Discretionary Review Abbreviated Analysis HEARING DATE: MAY 14, 2020

Date: May 7, 2020
Case No.: **2018-005918DRP-02**
Project Address: **254 Roosevelt Way**
Permit Application: 2019.0212.2711
Zoning: RH-2 [Residential House, Two-Family]
40-X Height and Bulk District
Block/Lot: 2607 / 029
Project Sponsor: Linda Kahn
720 York Street #107
San Francisco, CA 94123
Staff Contact: David Winslow – (415) 575-9159
david.winslow@sfgov.org
Recommendation: **Take DR and Approve with Modifications**

Discretionary Review Hearing
 Case Number 2018-005918DRP-02
 254 Roosevelt Way

Fig. 5B
Original 311 elevation, with street edge profile highlighted in blue.

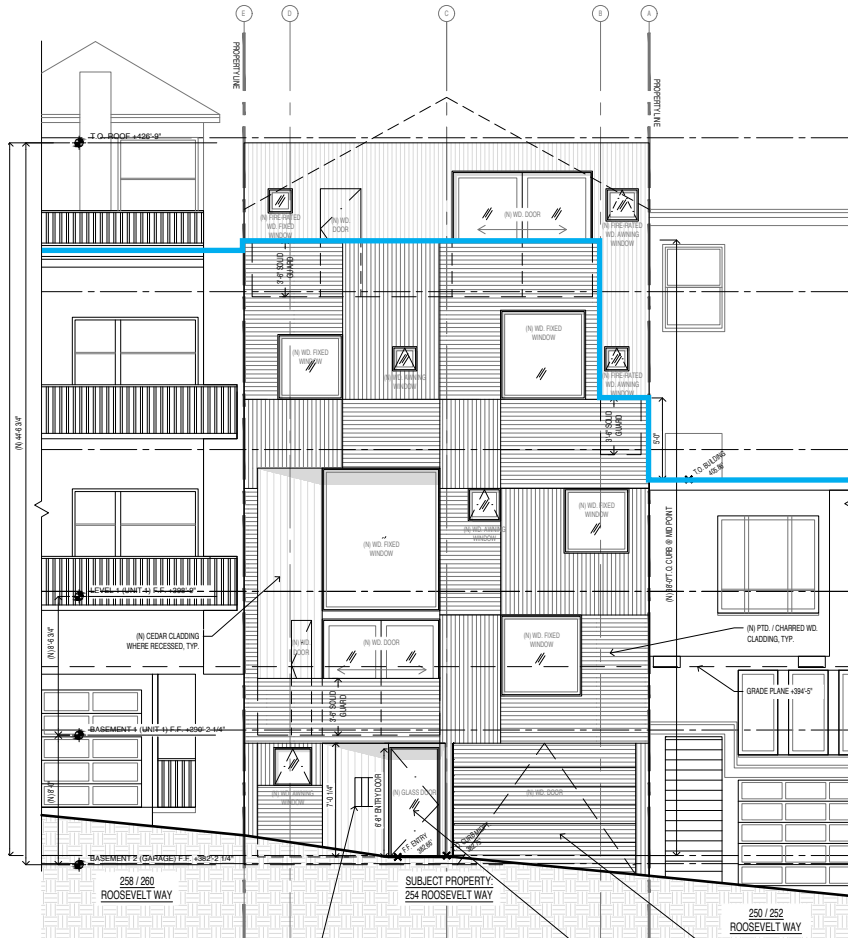
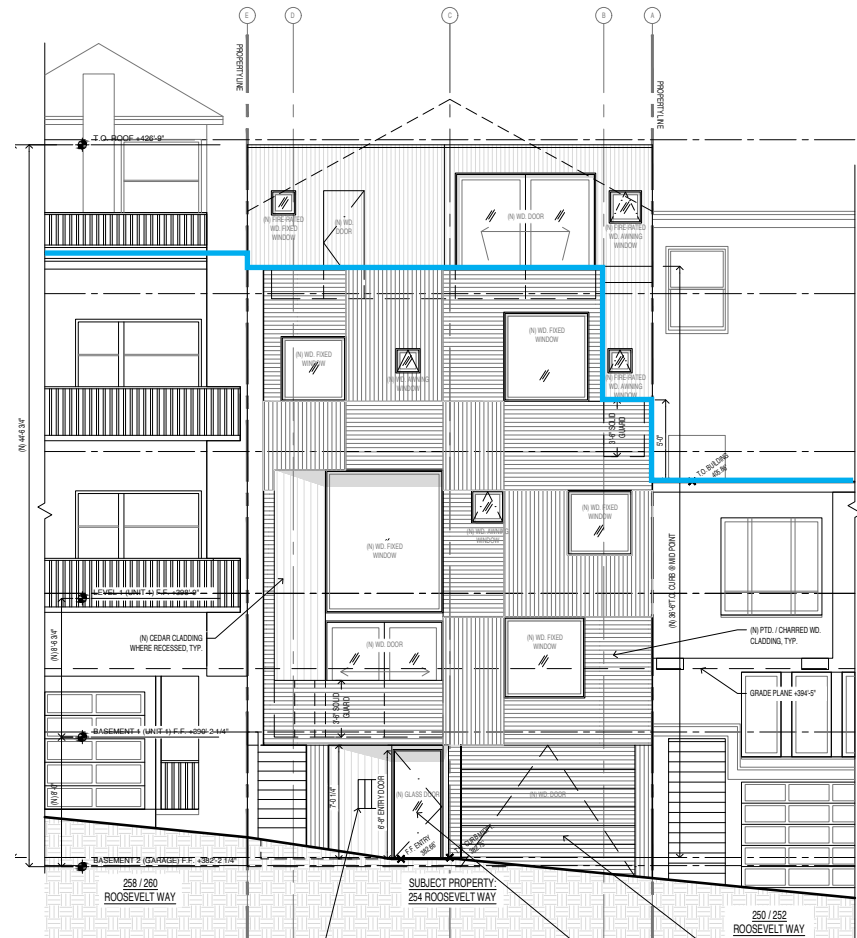
The current height of the building is within the allowable height by planning and zoning. The stepping down as mentioned between 258 and 250 is not a consistent rule to the street (See Fig. 5A). In fact if you examine the relationship between 262 and 258 (just one property further up the hill), we have a large two storey increase in height by 258 Roosevelt Way. The proposed development steps down along the front façade as it approaches 250 Roosevelt Way. *(Response continues on following page)*

We have addressed this issue by reducing the height of the parapet to allow for the stepping of the street edge to follow the topography.

Fig. 6C
Original 311 Plans with no setback.

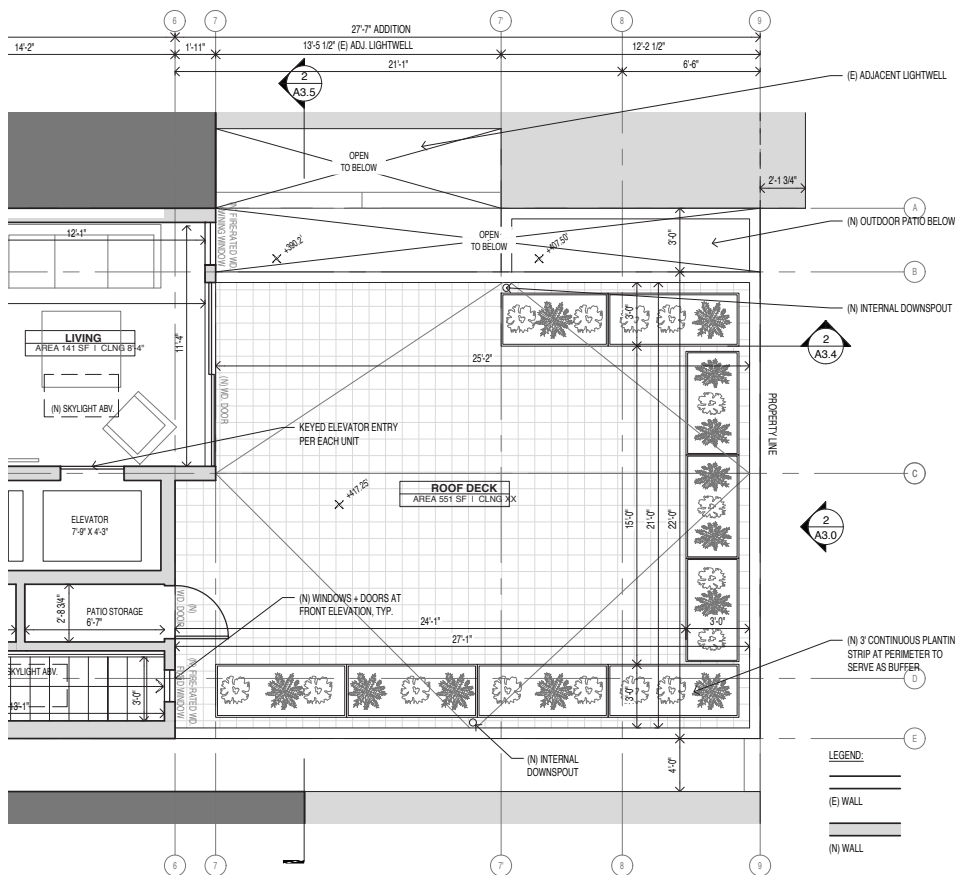
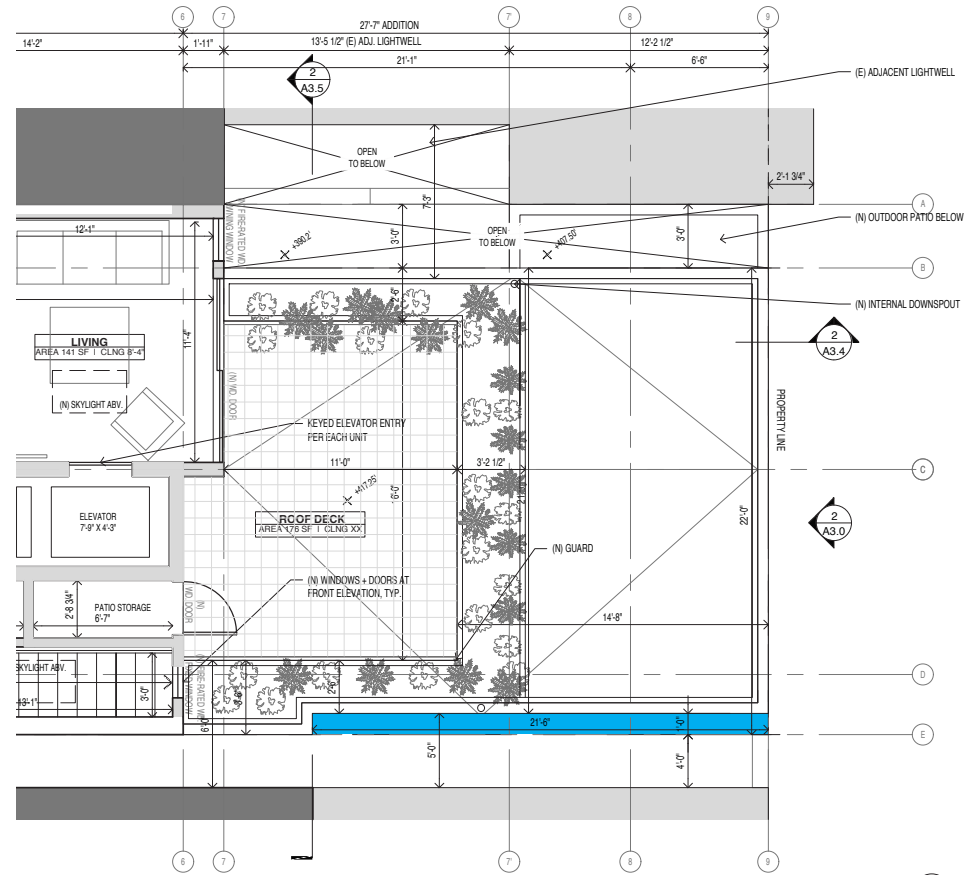
The current side setback of 258 is one of three set backs (including the property in question 254 Roosevelt) when examining the street elevation (See Fig 6A). The majority of houses on the street extend to the entirety of their property line. Our proposed design submitted at 311 would retain the current set back on the existing part of the house, and continue this to the front of the property. Lastly, the majority of the adjacent façade to 254 Roosevelt Way is without windows. The most impacted windows occur closer to the front of the property, where there is ample light provided from the front facade (See Fig 6B).

Although 258 Roosevelt Way's rooms receive ample light from the large, ceiling-to-floor, southern exposure windows, we still have introduced a 1'-0" setback from the property line, for a distance of 21'-6" from the front facade. This provides 5'-0" of separation between the two buildings. We have carried this setback throughout the entire facade, and in addition opened up the lower levels (see issue 7)
